# Access Compliance Report

## Public Rights-of-Way

Intersection ID: 46804	Main Street: ARBOR_CREST_CT	Cross Street: FOUNTAINGROVE_DR	Location: W
ADA ID: B03AD3EEE537	Ramp Type: Perp	Initial Pass/Fail: Fail	Overall Compliance: No
		Severity Score: 47.5

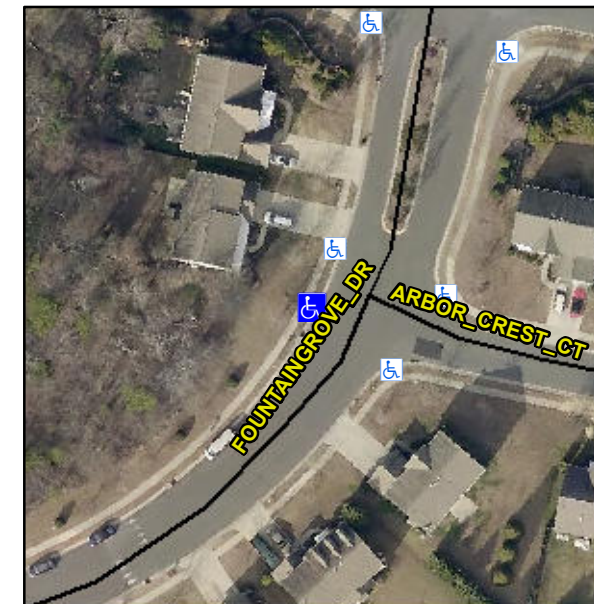
**R304.5.1, R304.2.2**

Compliance	Description	Data	Compliance	Description	Data
N/A	Ramp Length (in)	48.0	No	Ramp Slope (%)	9.5
No	Ramp Width (in)	28.5	Yes	Ramp XSlope (%)	0.4
N/A	Flare Type LT	N/A	N/A	Flare Type RT	N/A
N/A	Flare Slope LT (%)	N/A	N/A	Flare Slope RT (%)	N/A
N/A	Flare Traversable LT?	N/A	N/A	Flare Traversable RT?	N/A
N/A	Landing Length (in)	N/A	N/A	DWS Provided?	N/A
N/A	Landing Width (in)	N/A	N/A	DWS Contrast?	N/A
N/A	Landing Slope (%)	N/A	N/A	DWS Length (in)	N/A
N/A	Landing X Slope (%)	N/A	N/A	DWS Full Width?	N/A
N/A	Landing Curb? (Y/N)	N/A	N/A	DWS Offset (in)	N/A
N/A	Shared Landing?	N/A			
N/A	Gutter Ponding?	N/A	N/A	Gutter Slope (%)	N/A
N/A	Gutter Lip Ht (in)	N/A	N/A	Gutter X Slope (%)	N/A
N/A	Painted X Walk1?	No	N/A	Painted X Walk2?	N/A
	X Walk 1 Direction	To SE		X Walk 2 Direction	N/A
N/A	X Walk 1 Width (in)	N/A	N/A	X Walk 2 Width (in)	N/A
	X Walk 1 Slope (%)	4.0		X Walk 2 Slope (%)	N/A
	X Walk 1 X Slope (%)	0.5		X Walk 2 X Slope (%)	N/A

**Remove & Replace Entire Ramp.**
